Sundry Print Report

Well Name: OLIVE WON UNIT

Well Number: 22H

Type of Action: APD Change

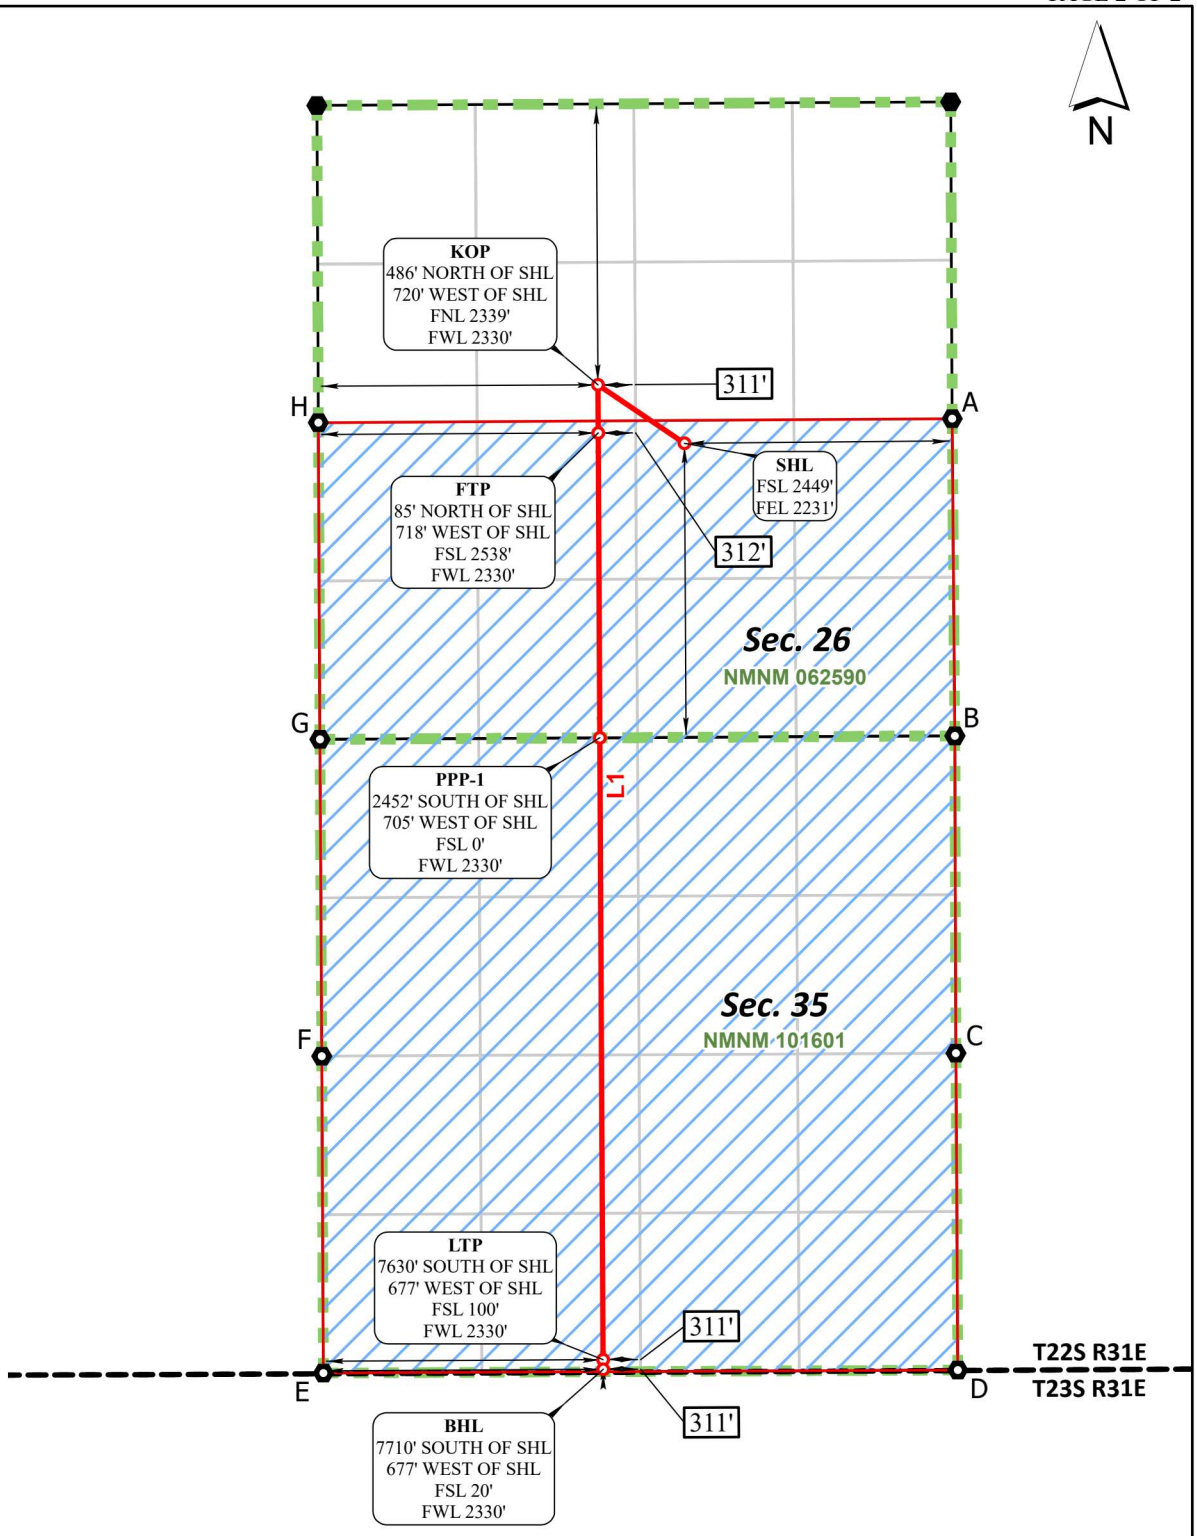
Procedure Description: OXY USA Inc., respectfully requests to amend the subject AAPD to revise the SHL, BHL, HSU, TVD and Drill Plan. Old SHL: 2613' FSL 1853' FWL New SHL: 2449' FSL 2231' FEL Old BHL: 20' FSL 2280' FWL New BHL: 20' FSL 2330'FWL Old HSU: 240 acres New HSU: 960 acres Old TVD: 10400' New TVD: 10370' *THERE IS NO ADDITIONAL SURFACE DISTURBANCE RELATED TO THIS SUNDRY" Attached is the updated C102, drill plan, directional, Blanket Design, Updated Variances and APD Change Worksheet.

OXY USA Inc., respectfully requests to amend the subject AAPD to revise the SHL, BHL, HSU, TVD and Drill Plan.

BHL (NAD83)
X:721611.81' / Y:488201.30'
LAT:32.34078629 / LON:-103.74961594
